工程指示 / 要求簡箋(E.I.)

工程指示編號：EI / 2183 / 20

工程名稱：觀塘裕民坊

工程項目：幕牆 玻璃(T2,55G 廁所用欄河玻璃)

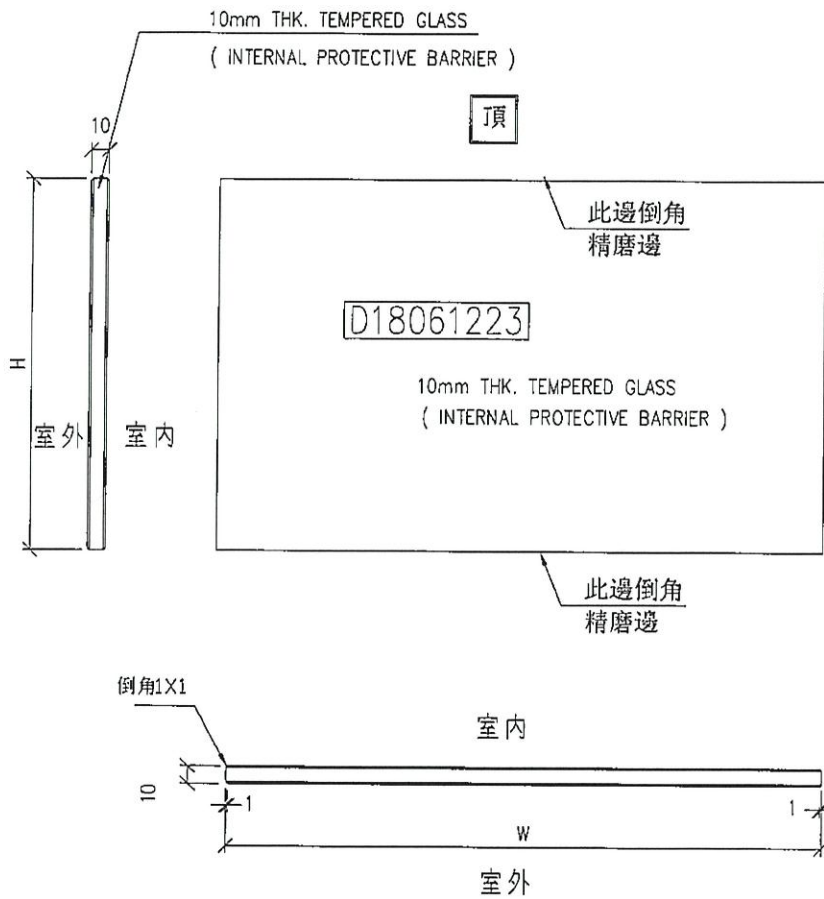
請按 BM 訂購玻璃送地盤安裝

因 T2,55G 位置，按 BD 要求浴缸至生窗欄河頂需要有 1100mm 高欄河玻璃高度需要加大
